1990 Corvette: Service Bulletin: SIR Revised Code 42 Chart

Number: 90-229-9

Subject: Service Manual Update - SIR Revised Code 42 Chart

Model Year: 1990 Y Car

CODE 42 INDICATOR LAMP CIRCUIT (OPEN CIRCUIT)

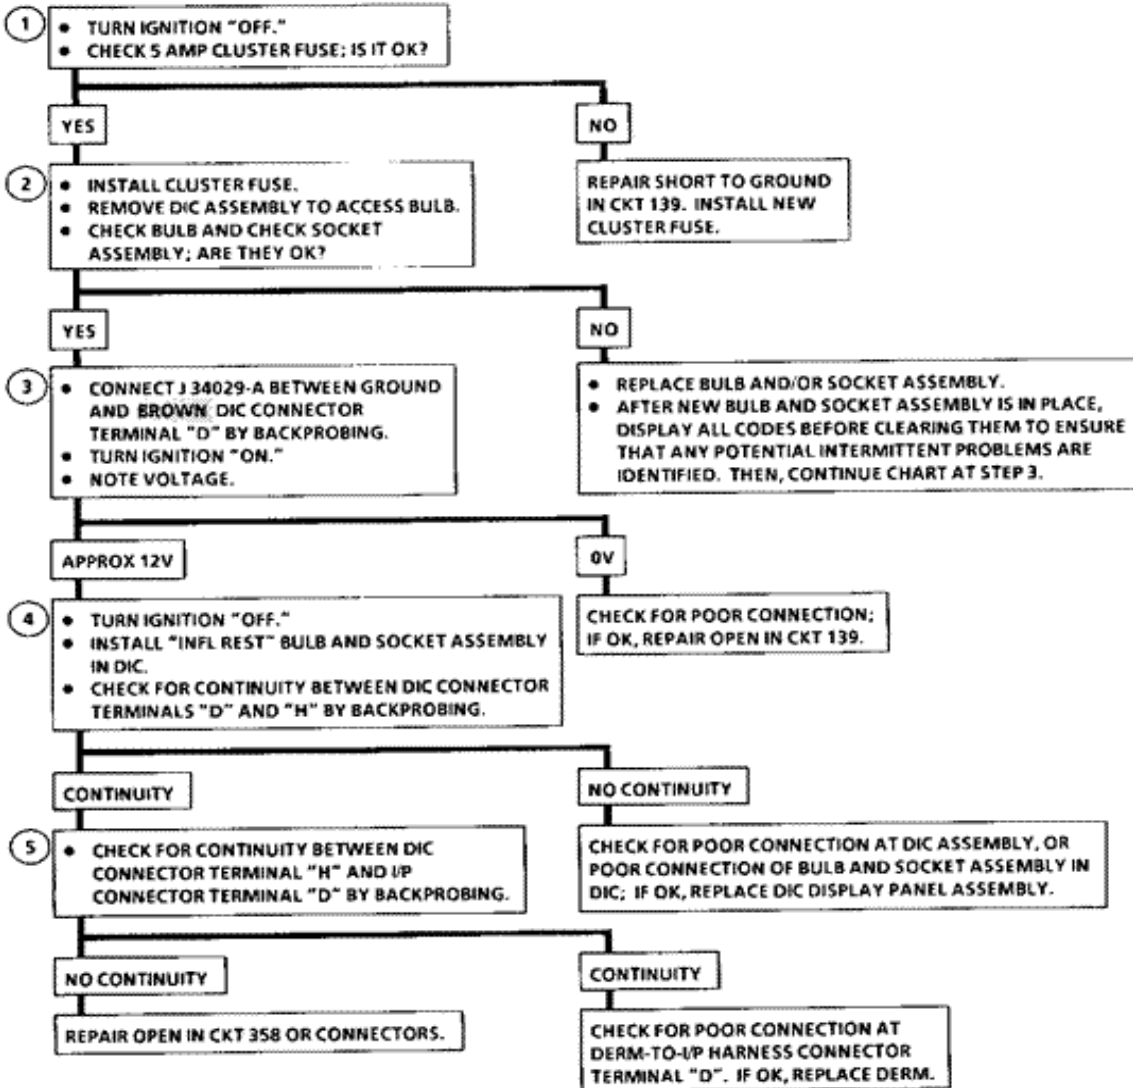
This bulletin serves to revise the Code 42 Chart on page 9J-A-43 in Section 9J-A "Supplemental Inflatable Restraint" in the 1990 "Y" Service Manual.

The blue connector referenced in the chart, step 3, should be a brown connector.

Revised art is attached.
